# Bradley Heights Apartments

## A 236-Unit Apartment Development Puyallup, Washington

### Bradley Heights SS LLC

**ROOF VENTING CALCULATIONS**

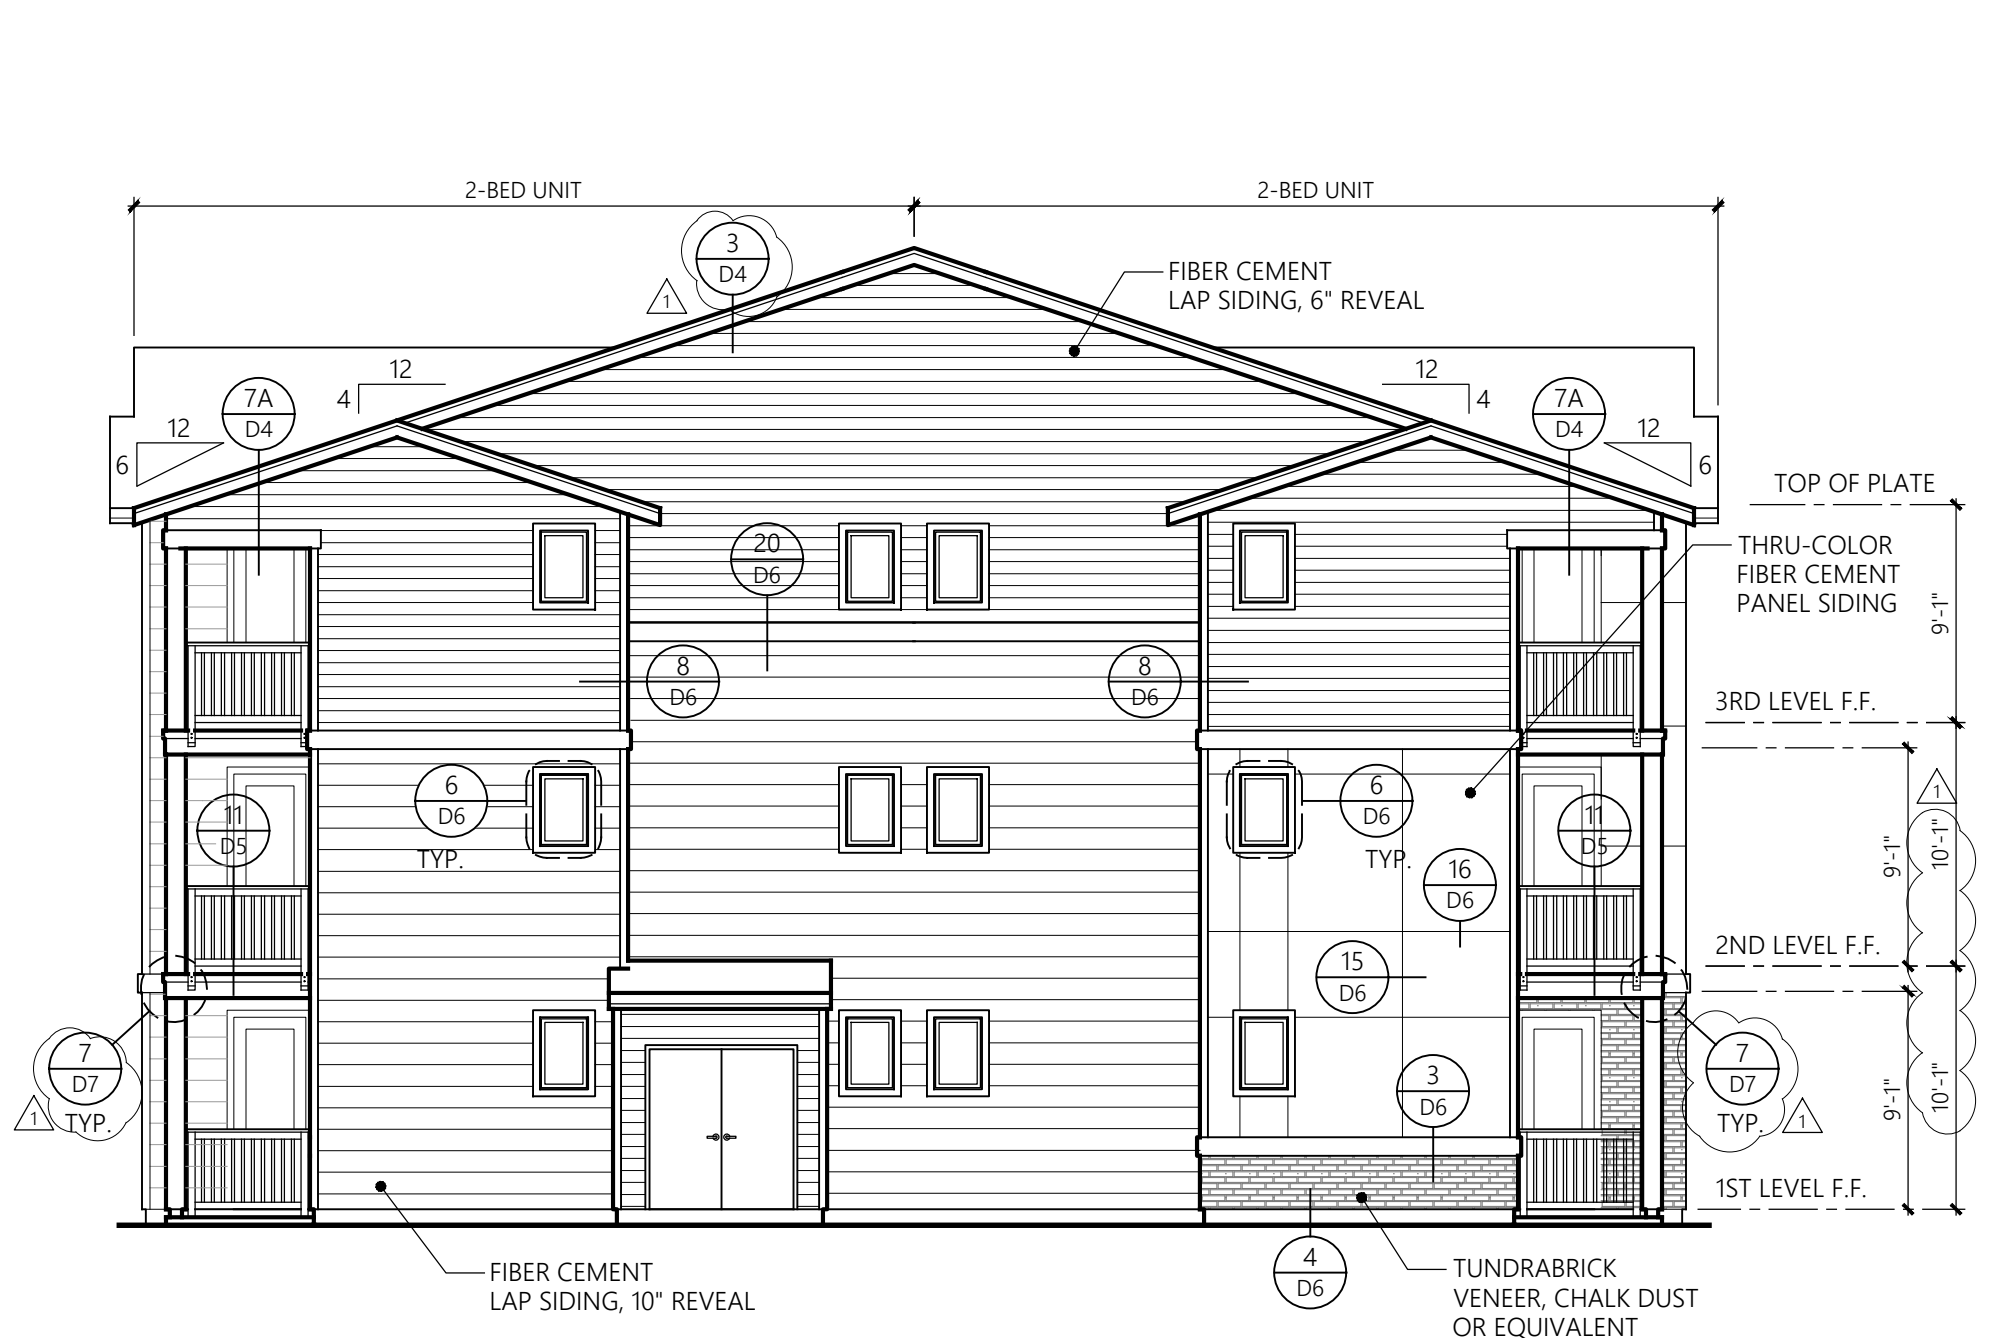
Detail and show draftstops in attic as needed per Washington State Building Code, 708.4.2. Update the attic ventilation as needed based upon changes for draftstops.  
(Construction Set, Sheet R8, Unit Plans)

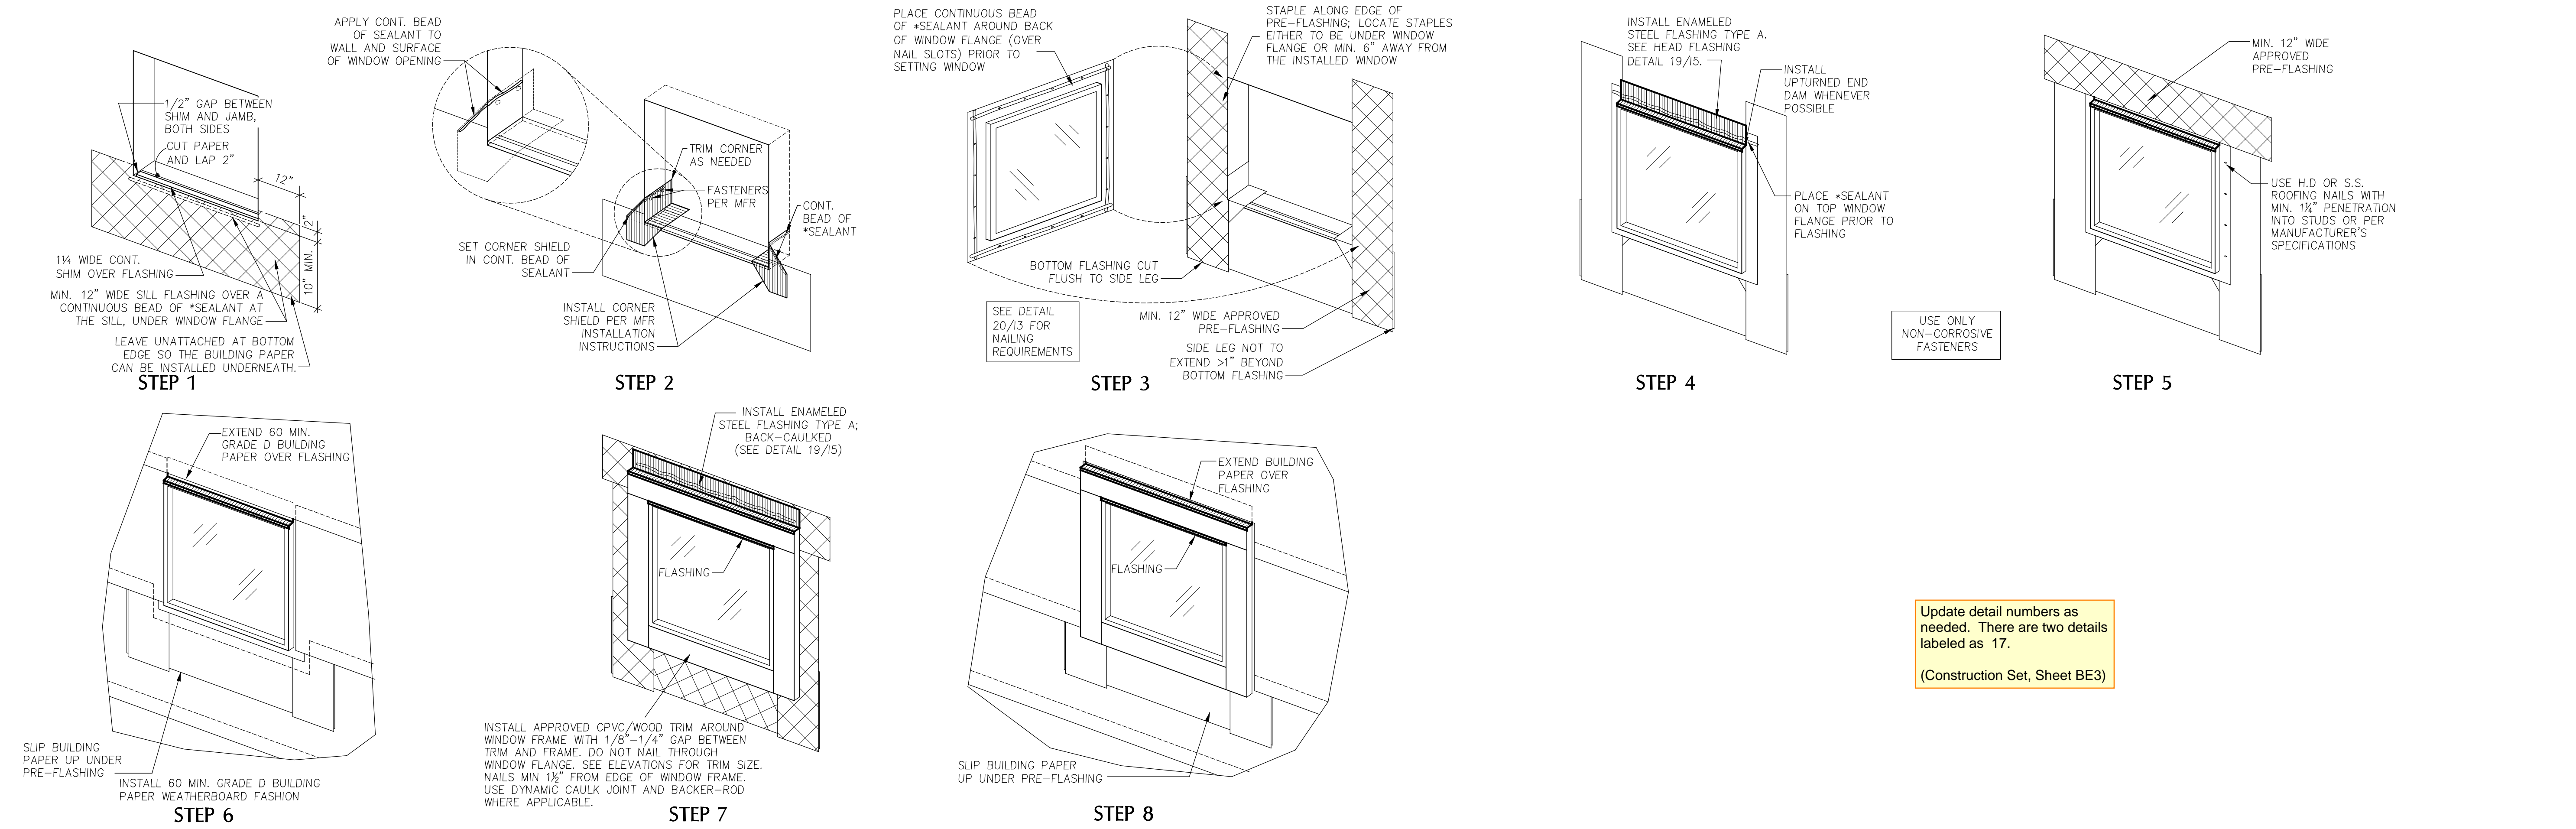
Update detail numbers as needed. There are two details labeled as 17.  
(Construction Set, Sheet BE3)

BUILDING H 1st LEVEL PLAN  
1/8" = 1'-0"  
3-STORY, 24-UNIT BUILDING

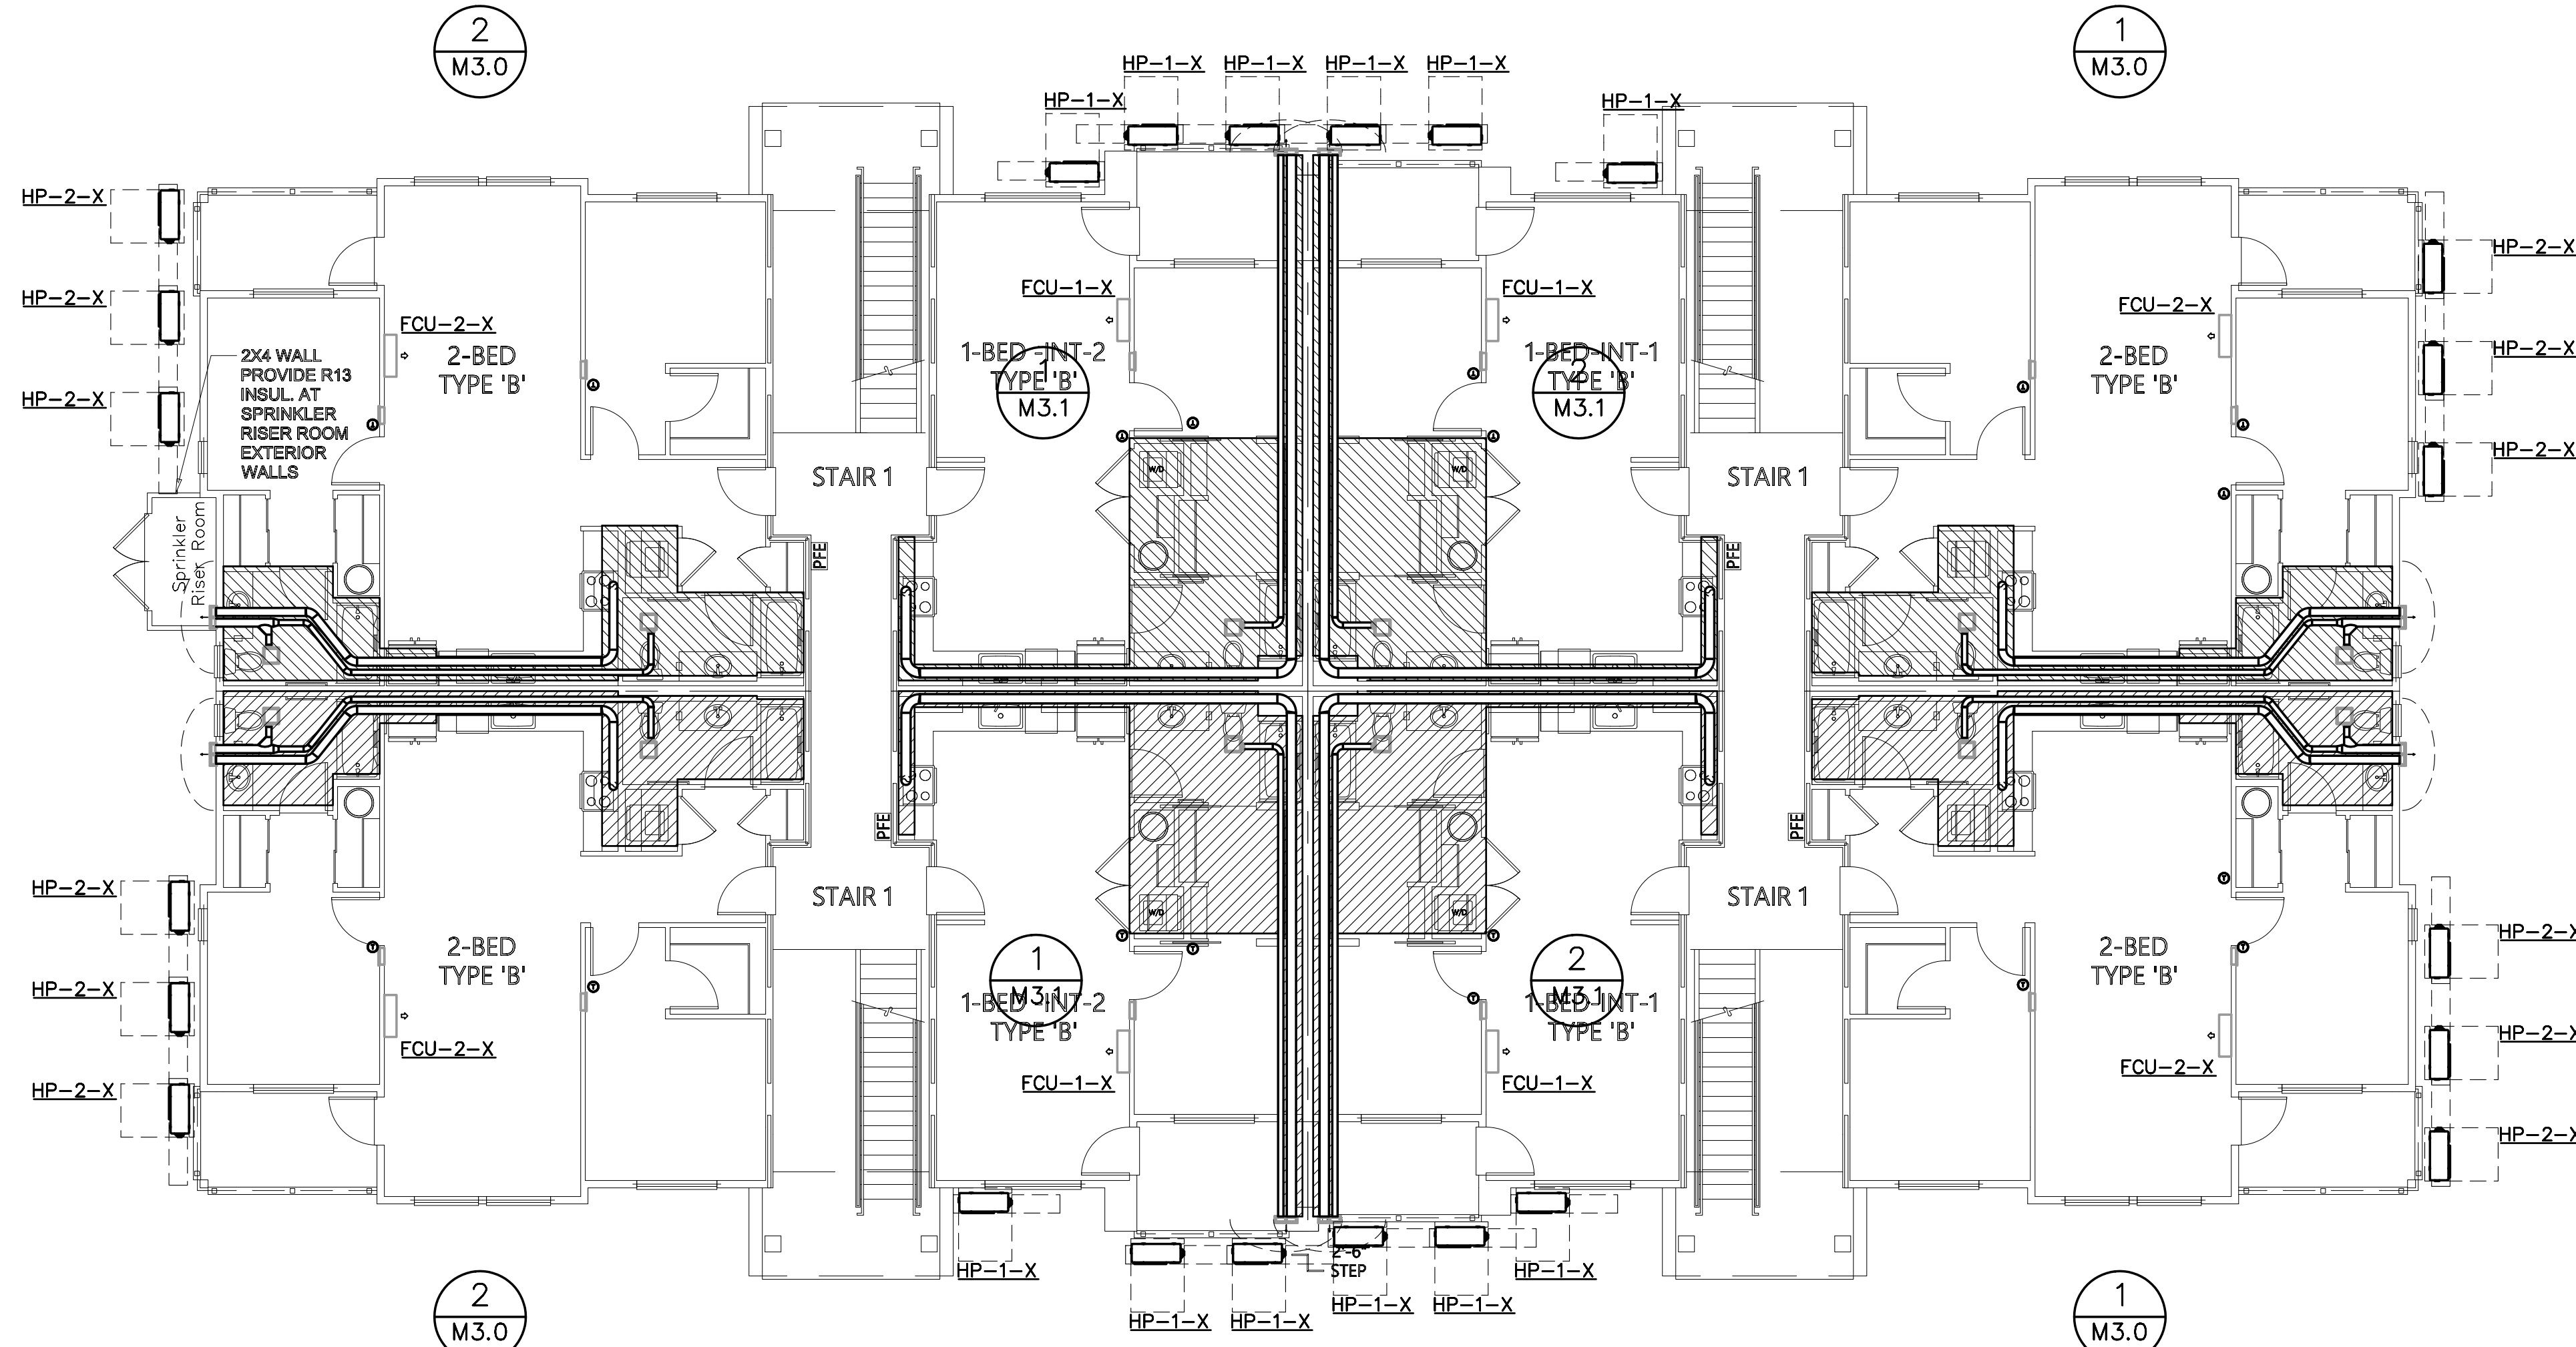
There are two duct runs that appear to terminate in the sprinkler riser room. The ducts are within a furred down ceiling to 8 foot and riser room plate is 9 foot with shed roof on top. update ducting design as needed.  
(Construction Set, Sheet M2, 1st Level Plan)
